DEALER NOTIFICATION – SAFETY RECALL

Subject: Demonstration / Delivery Hold / Stop Sale
Field Action No.: 11-102

SAFETY RECALL – Poor Performance of Fluid Heater Systems

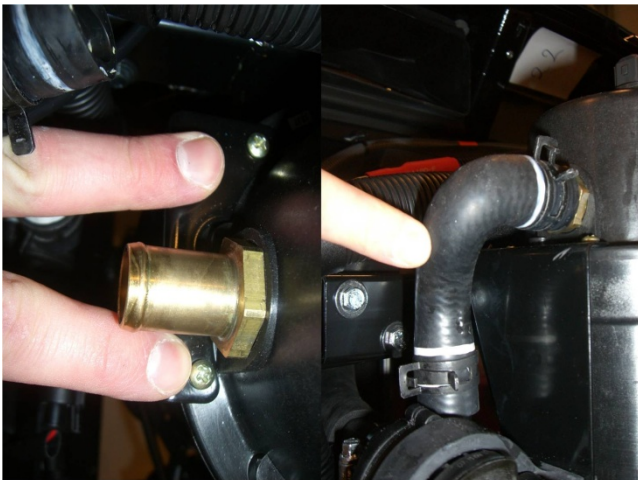
1. Drain coolant from radiator.
2. Disconnect supply power connection from PCU Unit.
3. Disconnect control connector from fluid heater
4. Disconnect heater hose connections from left and right side of fluid heater assembly

5. Remove two attaching screws from fluid heater mounting bracket and remove heater assembly from vehicle

6. Install new fluid heater assembly and attach mounting screws first.
7. Reconnect left and right heater hose connections.
8. Reconnect heater control and high voltage connections
9. Refill coolant and run circulating pump until all air is purged from the system.
